# Access Compliance Report

## Public Rights-of-Way

Intersection ID: 12958	Main Street: E_3RD_ST	Cross Street: S_DAVIDSON_ST	Location: E
ADA ID: D2F96F224A6D	Ramp Type: PerpDiag	Initial Pass/Fail: Pass	Overall Compliance: No
		Severity Score: 7.5

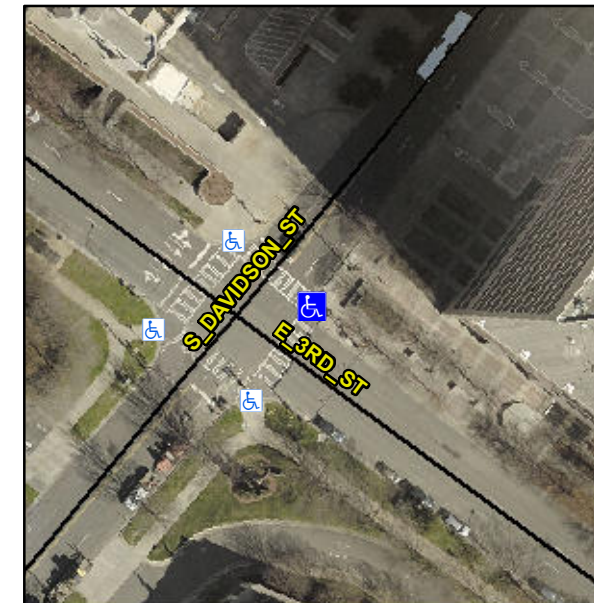
**R304.5.3, R305.2, R302.7.2**

Compliance	Description	Data	Compliance	Description	Data
N/A	Ramp Length (in)	82.0	Yes	Ramp Slope (%)	1.5
Yes	Ramp Width (in)	72.0	Yes	Ramp XSlope (%)	2.0
N/A	Flare Type LT	Sloped	N/A	Flare Type RT	N/A
N/A	Flare Slope LT (%)	3.5	Yes	Flare Slope RT (%)	0.5
N/A	Flare Traversable LT?	Yes	N/A	Flare Traversable RT?	Yes
Yes	Landing Length (in)	48.0	Yes	DWS Provided?	Yes
Yes	Landing Width (in)	48.0	Yes	DWS Contrast?	Yes
Yes	Landing Slope (%)	0.8	Yes	DWS Length (in)	24.0
No	Landing X Slope (%)	2.5	Yes	DWS Full Width?	Yes
N/A	Landing Curb? (Y/N)	No	No	DWS Offset (in)	6.5
N/A	Shared Landing?	No			
Yes	Gutter Ponding?	No	Yes	Gutter Slope (%)	2.5
No	Gutter Lip Ht (in)	0.5	Yes	Gutter X Slope (%)	0.7
N/A	Painted X Walk1?	Yes	N/A	Painted X Walk2?	Yes
	X Walk 1 Direction	To NW		X Walk 2 Direction	To SW
N/A	X Walk 1 Width (in)	111.0	N/A	X Walk 2 Width (in)	108.0
	X Walk 1 Slope (%)	4.1		X Walk 2 Slope (%)	3.1
	X Walk 1 X Slope (%)	1.7		X Walk 2 X Slope (%)	1.2

Yes	Ramp inside XWalk1?	Yes	Yes	Ramp inside XWalk2?	Yes
	Road Slope (%)	1.2	N/A	Clear Space?	Yes
	Road X Slope (%)	4.8	Yes	Clear Space to XWalk (in)	64.0
Yes	Any Obstructions?	No	Yes	Storm Grate/Utility Hazard?	No
	Obstruction Type			Storm Grate/Utility Type	
		N/A			N/A
			Yes	Surface Condition? (G/P)	Good

**Remove & Replace Curb Ramp With Two New Directional Ramps or Equivalent. Grind Gutter Lip.**
